ILLINOIS POWER COMPANY

Subject: Clinton Power Station Unit #1  
Effects of Valve Flexibility in  
Dynamic Piping Analysis

NRC Questions

# EXHIBIT 2

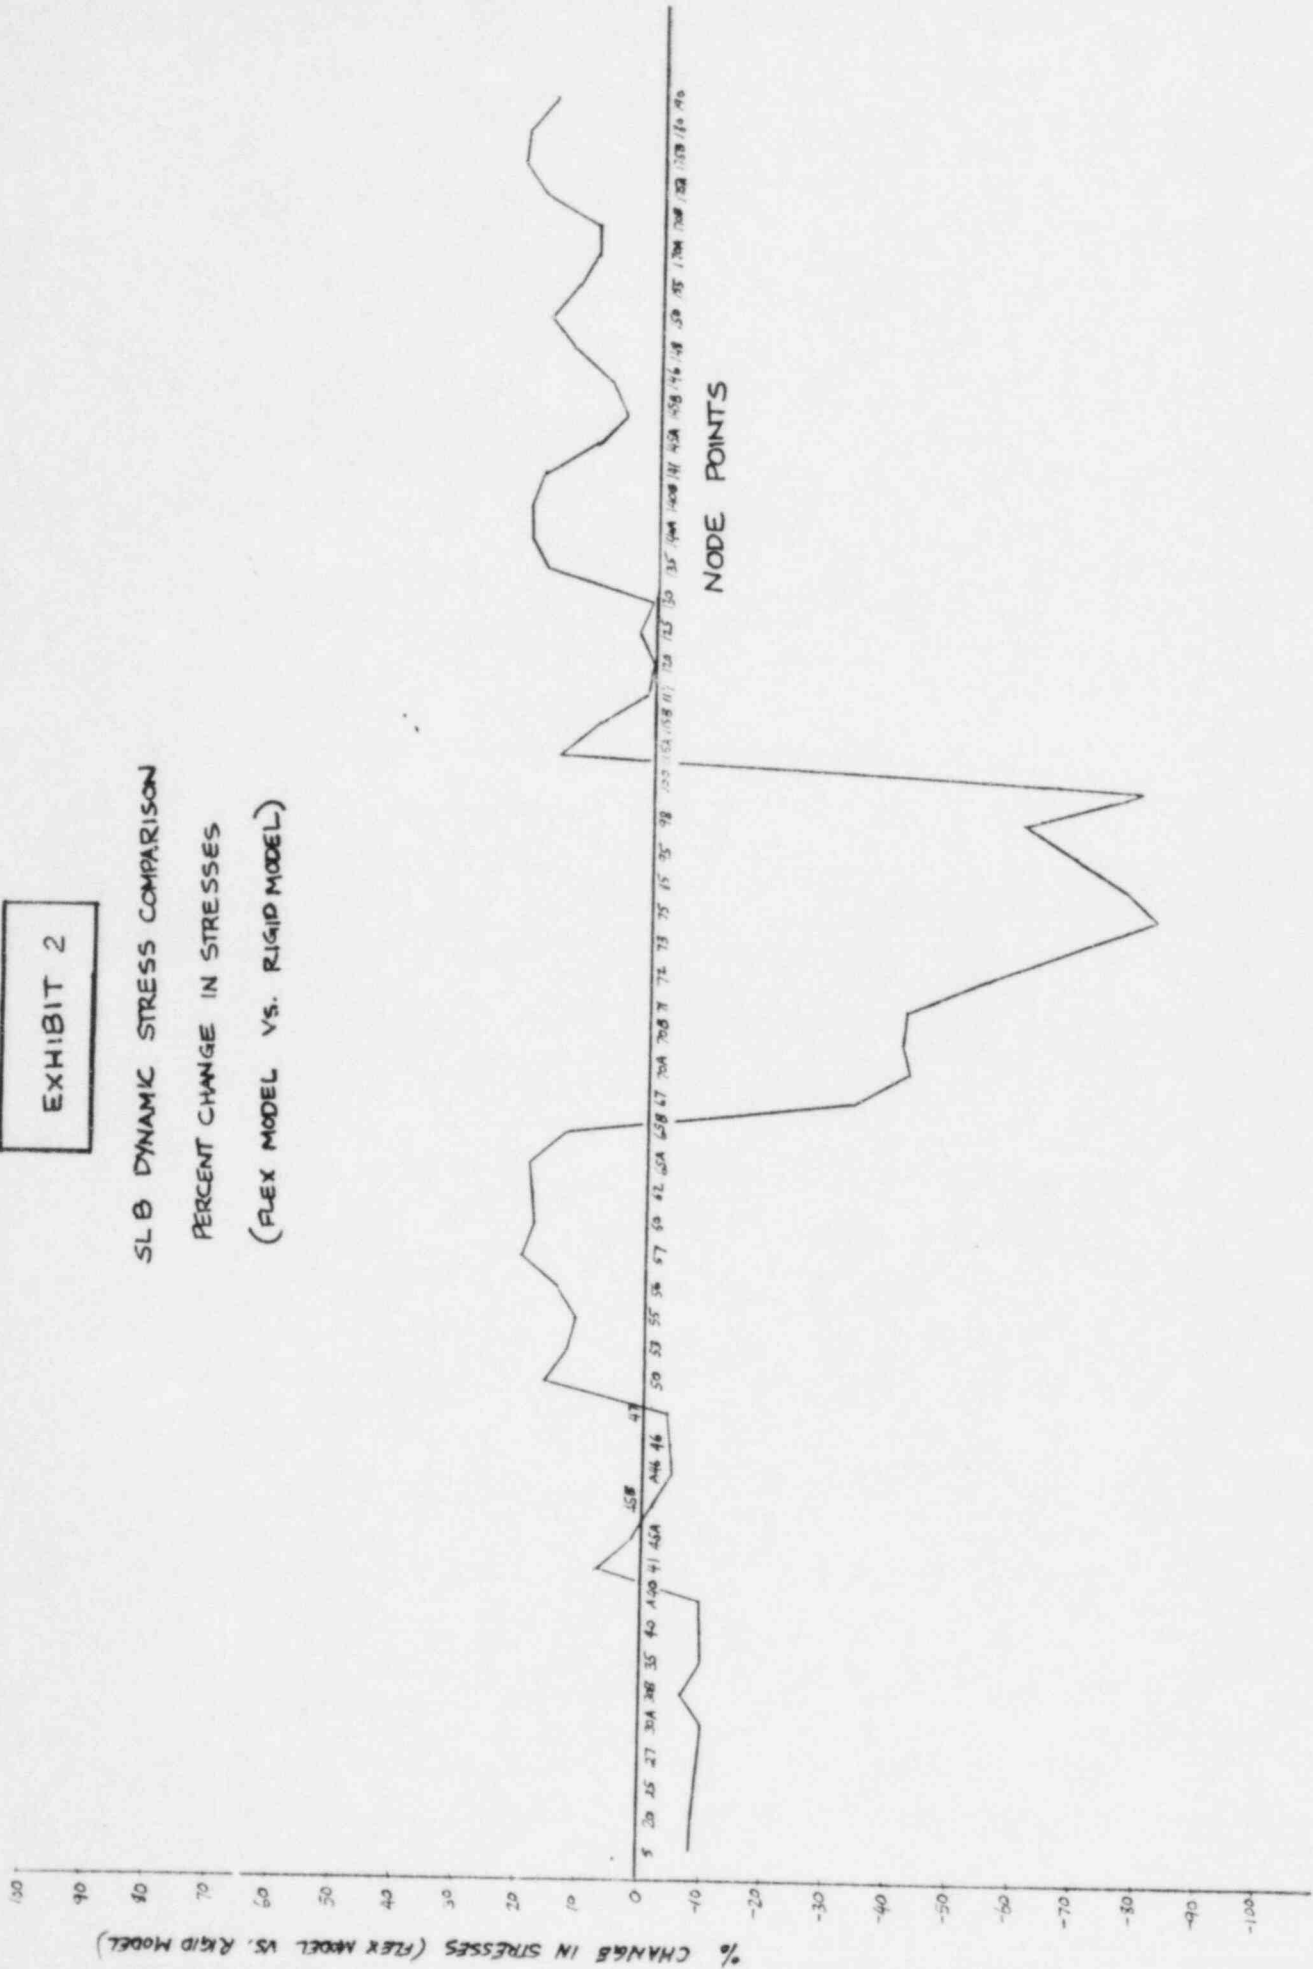
- A. Explain the apparent inconsistency between the FSAR commitment (Reference FSAR Q&R Chapter 3, response to MEB (DSER) Item No. 49) and the S&L consideration of flexible valves.
- B. Provide a list of all valve/operator assemblies with natural frequencies less than 33Hz, the vendor, the acceleration values for which the valves are qualified, and the calculated valve acceleration value.
- C. Provide an assessment of the effects of the flexible vs rigid valve modeling in piping stress analyses and include any differences in the calculated valve accelerations, piping stresses, and support loads resulting from the rigid and flexible valve model.

To confirm this position, a piping subsystem (1HP-04) with a flexible valve was analyzed with the standard "rigid" valve model and with the "flexible" valve model. This subsystem is comprised mostly of 20" diameter and 16" diameter piping. The flexible valve (valve no. 1E22F015) is a 20" motor-operated gate valve with a fundamental frequency of 14.9 Hz. It should be noted that in the flexible valve model the geometry of the valve body was simplified for modeling purposes, and conservatively increases the overall flexibility of the valve assembly. Exhibits 1 through 3 document a comparison of the results of these analyses.

Pipe stress differences between the rigid and flexible analysis are minor, and all increased stresses from the flexible analysis are within Code allowables. The analysis also indicates an insignificant change in total system stresses.
